**URGENT FIELD SAFETY NOTICE  
 MEDICAL DEVICE CORRECTION  
 FSCAs 2249723-06/02/2023-010-C, 2249723-06/02/2023-011-C,  
 2249723-06/02/2023-013-C & 2249723-06/02/2023-014-C  
 Datascope Cardiosave Hybrid and Rescue Intra-Aortic Balloon Pumps (IABP)**

Product Description:	Product Code/Part Number:	UDI Code:
Cardiosave Hybrid	0998-00-0800-31 0998-UC-0800-31	10607567109053 N/A
Cardiosave Hybrid	0998-00-0800-32	10607567111117
Cardiosave Hybrid	0998-00-0800-33 0998-UC-0800-33	10607567109008 N/A
Cardiosave Hybrid	0998-00-0800-34	10607567111940
Cardiosave Hybrid	0998-00-0800-35	10607567109107
Cardiosave Hybrid	0998-00-0800-45	10607567108421
Cardiosave Hybrid	0998-00-0800-52 0998-UC-0800-52	10607567108438 N/A
Cardiosave Hybrid	0998-00-0800-53 0998-UC-0800-53	10607567108391 N/A
Cardiosave Hybrid	0998-00-0800-55 0998-UC-0800-55	10607567108414 N/A
Cardiosave Hybrid	0998-00-0800-65	10607567113432
Cardiosave Rescue	0998-00-0800-75	10607567112312
Cardiosave Rescue	0998-00-0800-83	10607567108407
Cardiosave Rescue	0998-00-0800-85	10607567113449

*Figure 2-5: Grasping the Fiber-Optic sensor connector*

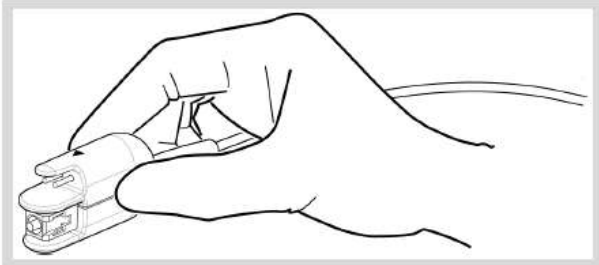
The Fiber Optic connector is designed to fit smoothly into the IAB Sensor Input. The red triangle on the top of the connector should align with the red triangle on the Cardiosave console. Inserting the Fiber Optic connector into the port without verifying the correct alignment can lead to internal damage. If difficulty is encountered when inserting the connector, verify that the connector is in the correct position and attempt to reinsert into the IAB Sensor Input.

Excessive force can cause damage to the connector and the internal fiber optic assembly of the IABP console. This may cause a disruption in the fiber optic signal acquisition resulting in an inability to acquire a fiber optic signal on the Cardiosave IABP. Following proper insertion procedures will minimize the potential for damage to the connector and a loss of signal. This conclusion is based on field observations seen through the complaints evaluation. As part of Datascope's investigation testing will be performed to confirm this observation.

1. With one hand, grasp the Fiber-Optic Sensor Connector as shown in Grasping the Fiber-Optic sensor connector, with the red triangle visible on top.

**Note:**  
Ensure that the red triangles on the Fiber-Optic IAB Sensor Connector and on the back panel are in alignment.

In step 4, when the Fiber-Optic connector is inserted into the IAB Sensor input until an audible "click" is confirmed, ensure that you are not using excessive force as that can lead to damage to the Cardiosave.
